MEMORANDUM

Re: WRSP PCL F-25 & F-26 Fiddymment Bungalows – Response to Neighbors Letter

Re: WRSP PCL F-25 and F-26 – Fiddymment Bungalows (File# PL20-0258)

Figure 1. Architectural Comparison to Existing Homes

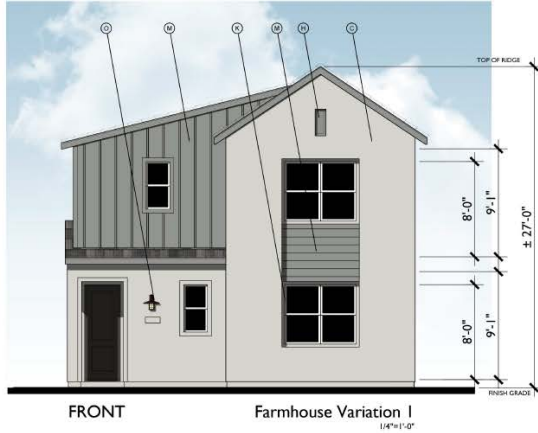
Color: The bright white paint proposed for some of the buildings does not “[c]onsider and respond to the relationship and context of adjacent projects.” (Community Design Guidelines, Multi-family Residential Development, p. 47.) It also does not compliment the neighborhood’s earthen colors and warm hues. (Specific Plan Design Guidelines, §12.1.3, p. 12-2; see Exhibit A.) The reflective white paint on large walls will make the apartment complex stand out from the surrounding community instead of “creat[ing] and enhanc[ing] a sense of community and neighborhood.” (Community Design Guidelines, Multi-family Residential Development, p. 47.) The white color scheme is not “harmonious with other development and buildings in the vicinity” given the placement of the project as a focal point and the towering scope of the project in relation to the neighboring homes. (City Municipal Code, § 19.78.060, subd. B.3.) Attached hereto as Exhibit B is a photo of a project with white walls currently under construction on Roseville Parkway and Gibson Drive. The exhibit demonstrates our point when compared to our existing community in Exhibit A.

Theme: The farmhouse theme is incompatible with the design of the surrounding neighborhood. (See Exhibit A.) The theme does not “create and enhance a sense of community and neighborhood,” nor does it “[c]onsider and respond to the relationship and context of adjacent projects.” (Community Design Guidelines, Multi-family Residential Development, p. 47.) Van Daele Homes simply reused a design from its Lathrop community without considering the characteristics of the existing neighborhood and the community within which the project would be built.³ The current design does not match the surrounding residential homes, which incorporate a mix of varied architectural themes to give the neighborhood an enhanced and custom appearance.

There are 6 color schemes proposed for the project. The letter refers to a “reflective” white color. One of the six base colors, Sherwin Williams Greek Villa, could be considered an off-white and it is not reflective. Farmhouse architectural style is used throughout the project. This style combines modern and traditional features, which are complementary to homes in the immediate area. Community Design Guideline MF-27 calls for multi-family projects to complement the context of adjacent and surrounding projects, but to avoid duplication in design. Copycat architecture is discouraged. Staff compared the proposed architecture and colors for the project to existing homes in the immediate vicinity of the project (Figure 1). The top image compares one of the variations of Plan 3 in the project to the existing home at 4065 Chuckwagon Wy. located across the street from the project site. Complementary features include the two-story height, color scheme, base material of stucco, and vertical accent siding. The bottom image compares another variation of Plan 3 to an existing home at 5024 Stetson St. located approximately 160 feet from the project site. Complementary features include the two-story height, earth tone color scheme, base material of stucco, and horizontal accent siding. While the Farmhouse style is not a copy of any existing home in the area, there are a number of complementary colors, materials, and architectural features that meet the intent of the Community Design Guidelines.
